SUNDRY NOTICES AND REPORTS ON WELLS
Do not use this form for proposals to drill or to re-enter an abandoned well. Use Form 3160-3 (APD) for such proposals.

Elk San Juan intends to plug and abandon the Ute Mountain Tribal #24-43 well according to the attached procedure. The procedure will be handled by A-Plus Well Service, Inc. and the timing will be dependent upon their rigs' availability.

PLUG AND ABANDONMENT PROCEDURE

Ute Mountain Tribal 24-43

Proposed P&A

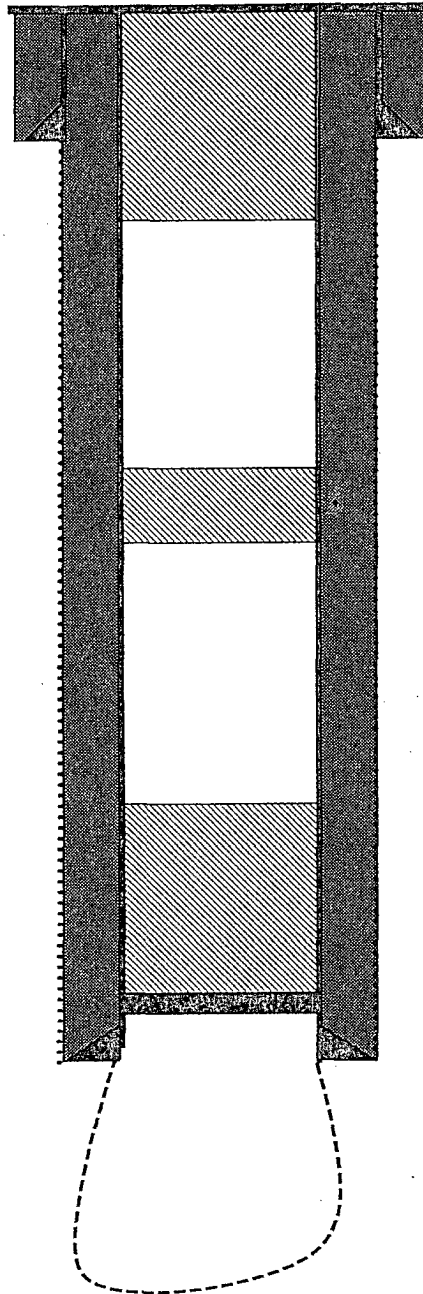
- 6a. **Cement plugs placed inside casing shall have sufficient volume to fill a minimum of 100 ft. of the casing or annular void(s) between casings, plus 10% excess volume per 1000 ft. of depth.**

- 6b. **Surface plugs must be a minimum of 50 ft. within casing and annular voids.**
 - 6c. **Cement plugs placed to fill an open hole shall have sufficient volume to fill a minimum of 100 ft. of open hole, plus 10% excess volume per 1000 ft. of depth.**

- 6d. **An additional 100 ft. cement plug must be placed midway between the Gallup and surface casing plugs.**
 - 6e. **Tag the Gallup Mesaverde plug.**

- 6f. **Tag the Pictured Cliffs plug.**
7. The well must be filled with a wellbore mud sufficient to stabilize the wellbore. In the absence of any formation pressure data provided by the operator, this mud will have a minimum weight of **9 ppg**. The mud must be left between all plugs.
